SERVICE BULLETIN

NO. 0048 PAGE 1 OF 1

MODIFICATION TO CARBON
DISC MOUNTING SYSTEM

MODIFICATION OF CARBON DISC RETAINING WASHER FOR INCREASED CLEARANCE TO CALIPER.

FIGURE 1

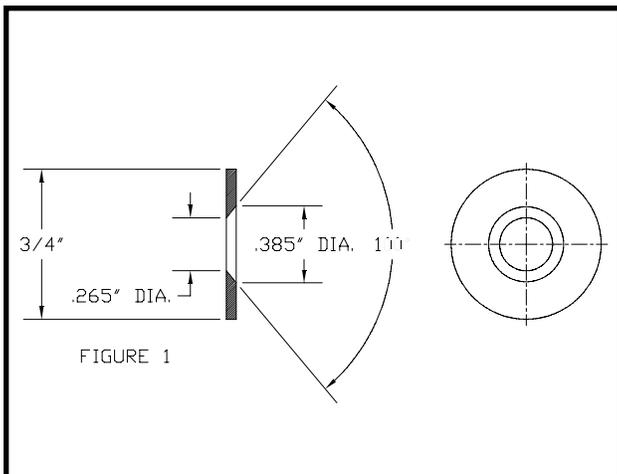
- 1) REMOVE OLD RETAINING SYSTEM HARDWARE.
- 2) WIPE CARBON FIBER BRAKE DISC WITH DRY CLOTH, BRAKE DISC ADAPTER WITH BRAKE CLEANER OR STANDARD SOLVENT.
- 3) CHAMFER #10 X 3/4" TITANIUM WASHER (#94051A010) TO PRINT BELOW
 - A. DRILL .265 DIAMETER HOLE (17/64") THRU WASHER
 - B. CHAMFER WITH 100 DEGREE CHAMFER TOOL UNTIL LARGE DIAMETER OF CHAMFER EQUALS .385" OR UNTIL FLAT HEAD SCREWS ARE FLUSH WITH WASHER. (SEE FIGURE 1)
 - C. CHECK THAT HEAD OF SCREW IS FLUSH OR SLIGHTLY BELOW WASHER (FIGURE 2)
- 4) CHAMFER ALUMINUM HUB (#55060/55065) WITH 100 DEGREE COUNTERSINK TOOL UNTIL LARGE DIAMETER IS .275 MINIMUM (FIGURE 2)
NOTE: MODIFIED WASHERS ARE AVAILABLE FROM MARK WILLIAMS ENTERPRISES IF FACILITIES ARE NOT AVAILABLE TO FIELD MODIFY THE ORIGINAL WASHERS.
- 5) ASSEMBLE DISC ADAPTER TO CARBON FIBER DISC USING MODIFIED WASHER AND FLAT HEAD SCREWS AND JET NUTS.

FIGURE 2

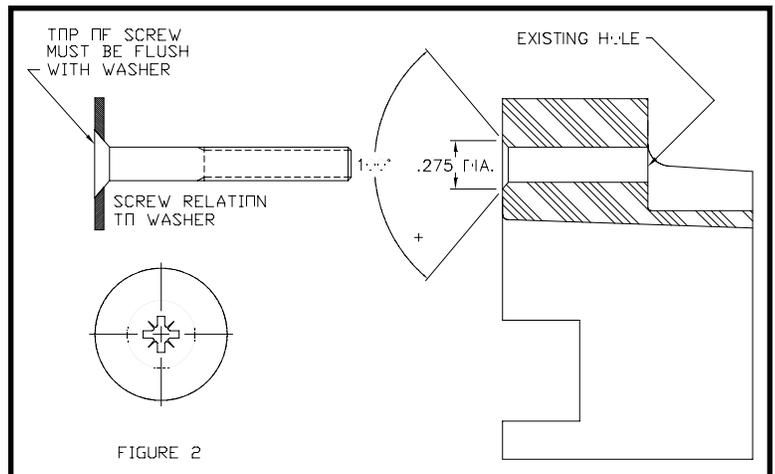
BRAKE KIT #81200 SHOWN

UNDER EXTREME CONDITIONS OF TIRE SHAKE THE CARBON FIBER DISC MOUNTING BOLTS CAN COME IN CONTACT WITH THE CALIPER MOUNT BRACKET THIS MODIFICATION ALLOWS FOR MORE CLEARANCE TO THE CALIPER MOUNT.
